### MEMORANDUM

**RE:** Tree Impact Assessment at Bell Street – SE 362<sup>nd</sup> Avenue

The City of Sandy requested my assessment and treatment recommendations for seven trees adjacent to construction of road improvements for the Bell Street – SE 362nd Avenue road construction project.

ESCP PLAN  
**BELL STREET - SE 362ND AVENUE**  
 SANDY, OREGON

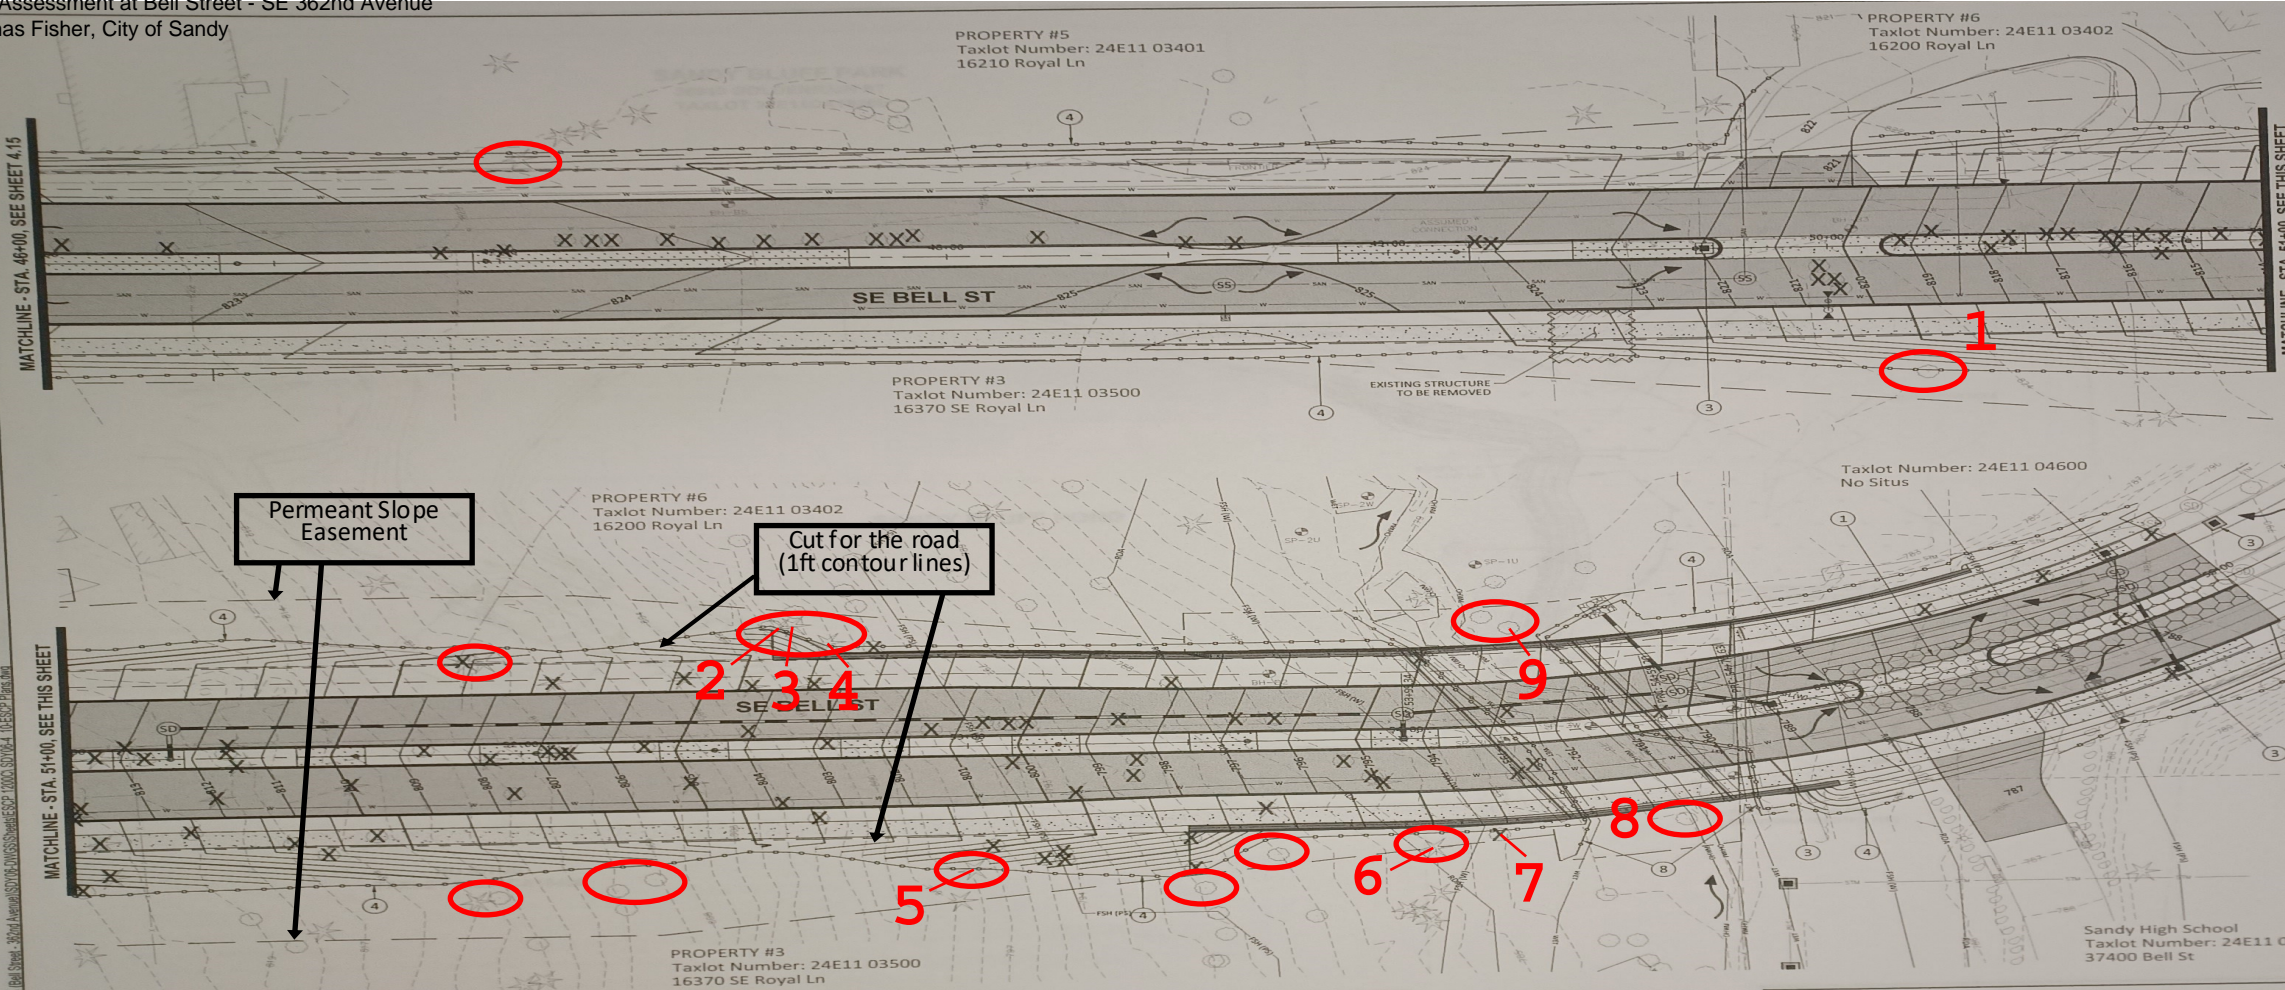
The seven trees that were the subject of my review are numbered on the site map provided to me by the city in Attachment 1. The assessment data including tree species (common and scientific names), trunk diameter (DBH), health condition, structural condition, pertinent comments, and treatment recommendations are provided for each tree in Attachment 2.

Based on the proposed impacts, I am recommending removal of six of the seven trees. One of the trees (tree 5) may be retained if fill soil will be limited to less than 50 percent of its estimated critical root zone.<sup>1</sup> The typical recommendation of my firm is to limit fill (and other root impacts) to 25 percent or less of a tree's estimated critical root zone. However, there is published research that indicates in some circumstances anywhere from 33 to 50 percent of the roots of healthy trees can be removed without serious effects.<sup>2,3,4</sup> In my opinion tree 5 is more likely than not to survive the impacts of the proposed fill so the city may decide to retain it. Note that this recommendation is not a guarantee the tree will survive, so retaining the tree is a calculated risk weighted against the benefits the tree provides.
